DREDGED MATERIAL MANAGEMENT PLAN AND ENVIRONMENTAL IMPACT STATEMENT

McNary Reservoir and Lower Snake River Reservoirs

APPENDIX A Hydrologic Analysis

**ERRATA SHEET
FOR
APPENDIX A - HYDROLOGIC ANALYSIS**

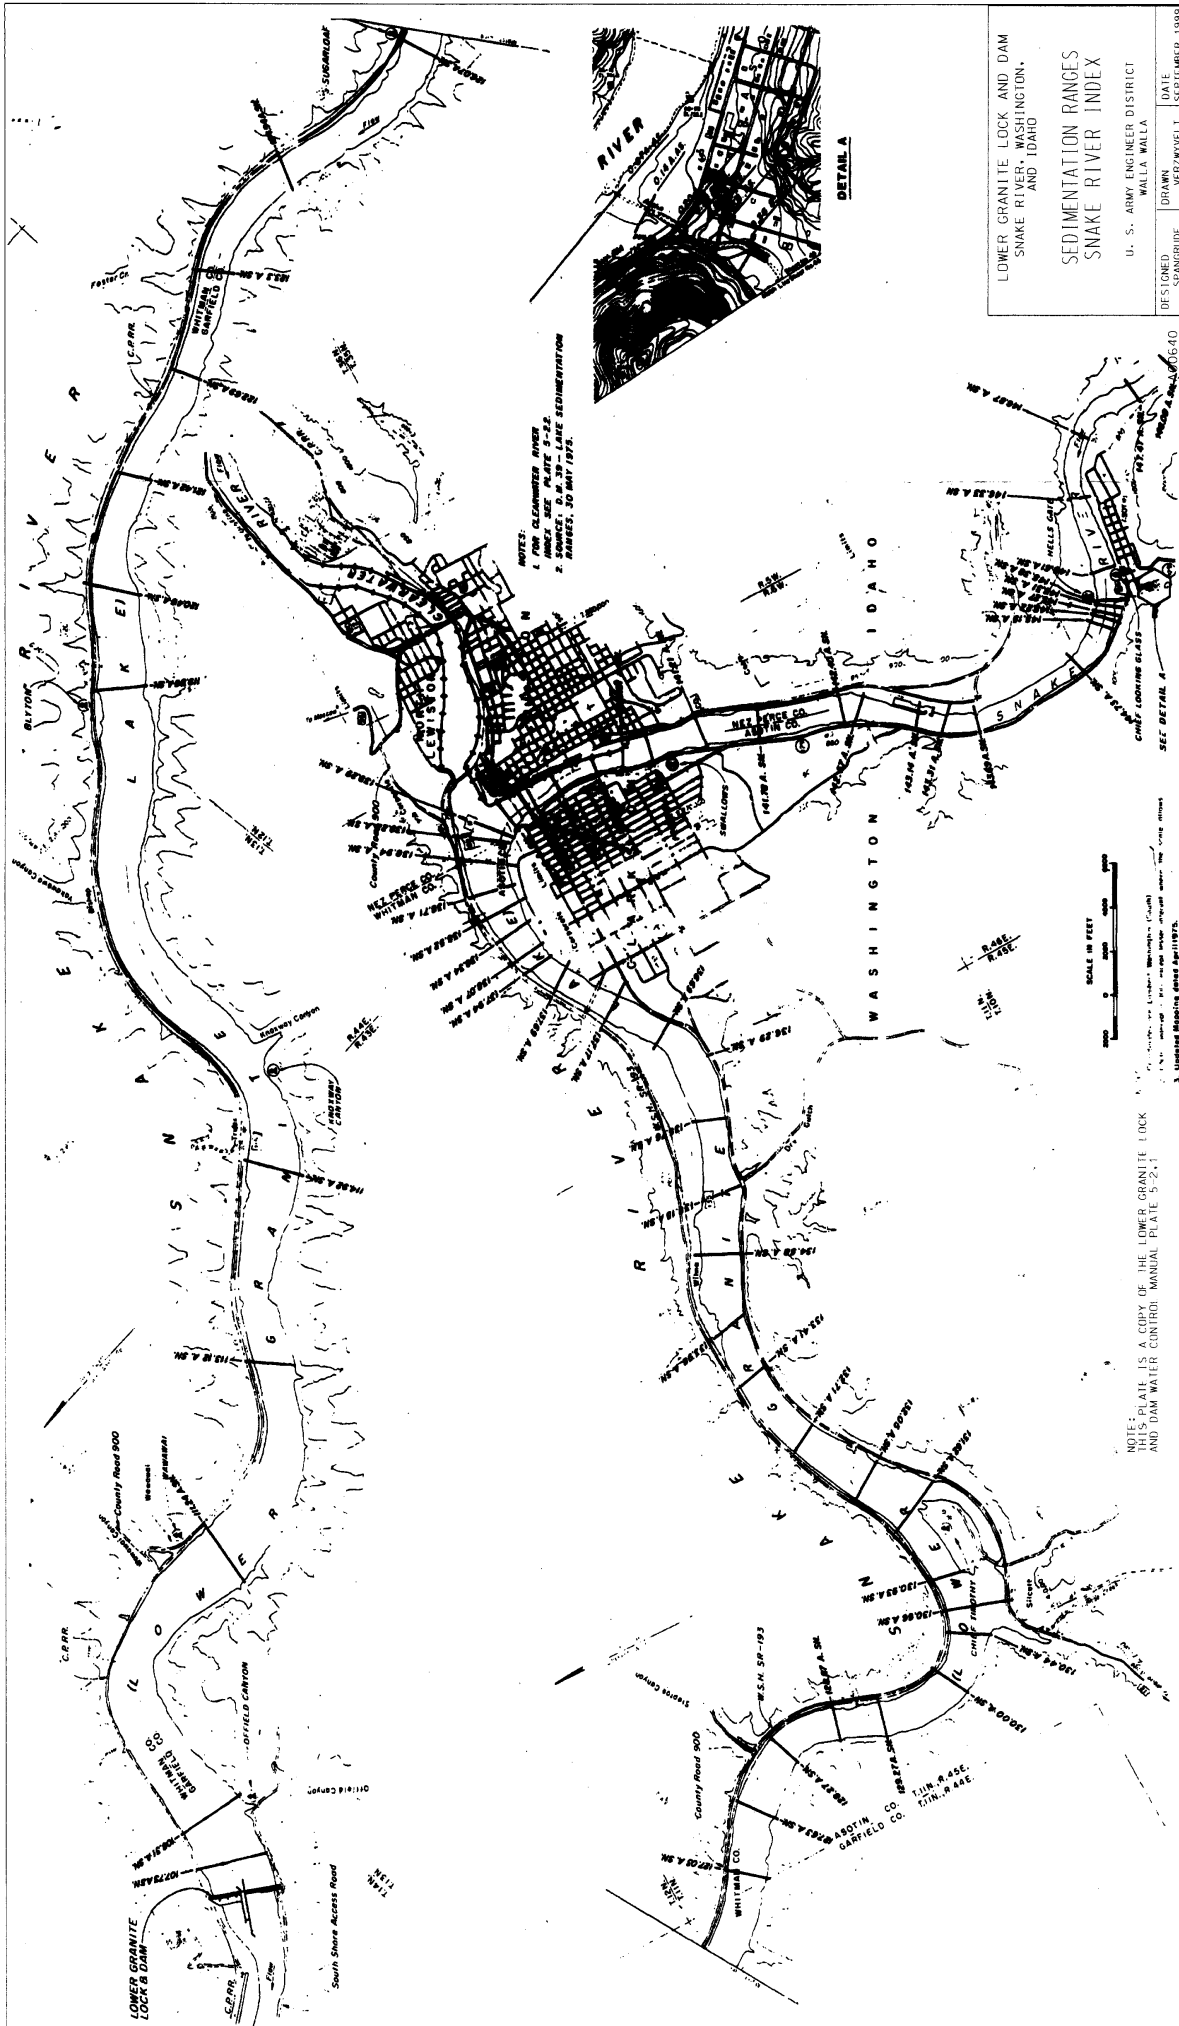
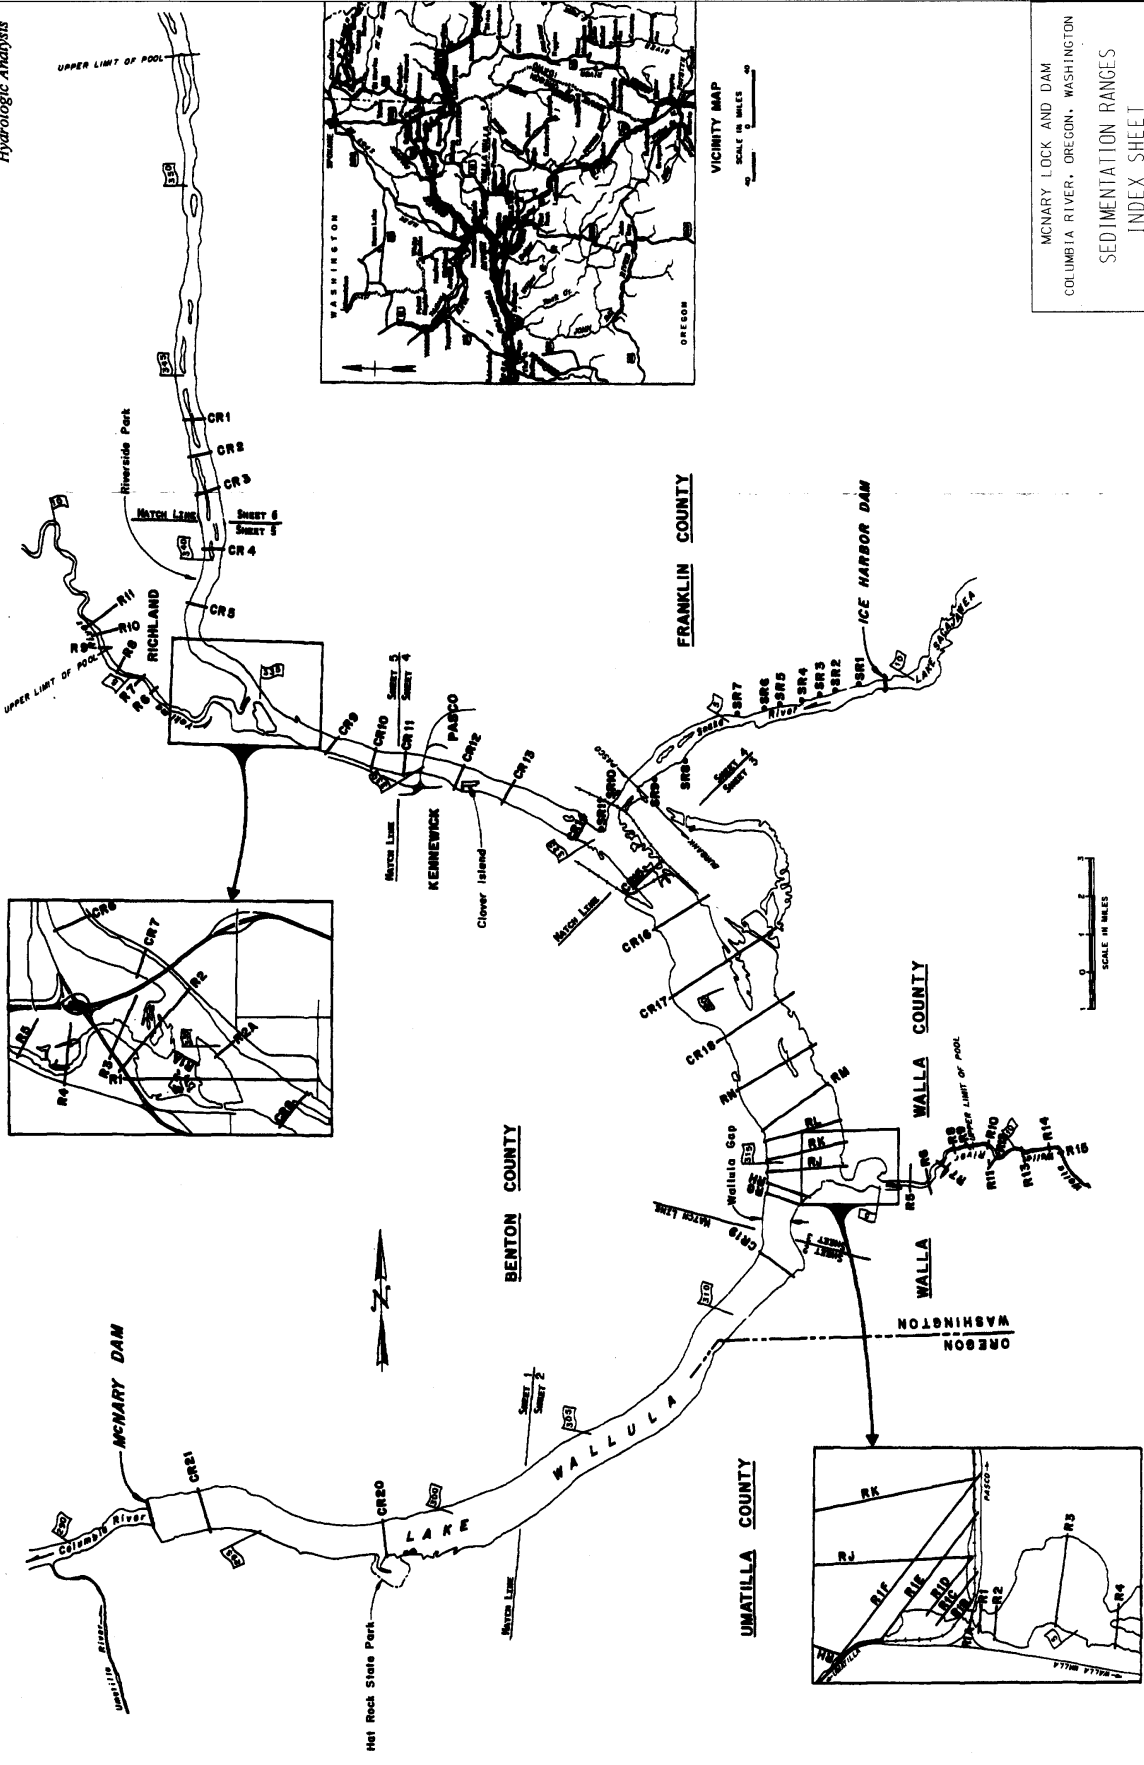
Title of Plate 5 should be: Snake River in Lower Granite Reservoir Sedimentation Ranges

McNary Sedimentation Ranges

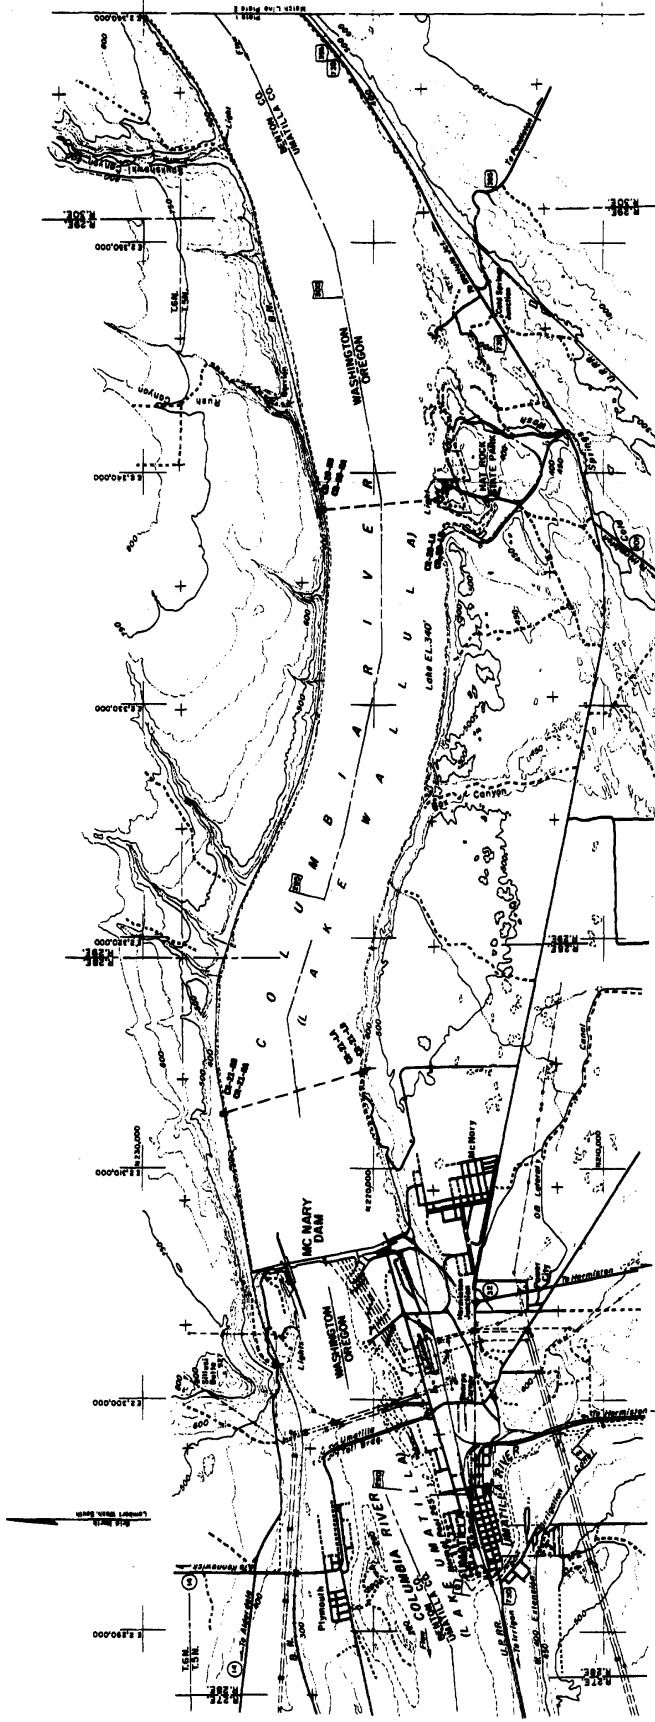
Title of Plate 7 should be: Columbia River in McNary Reservoir Sedimentation Ranges
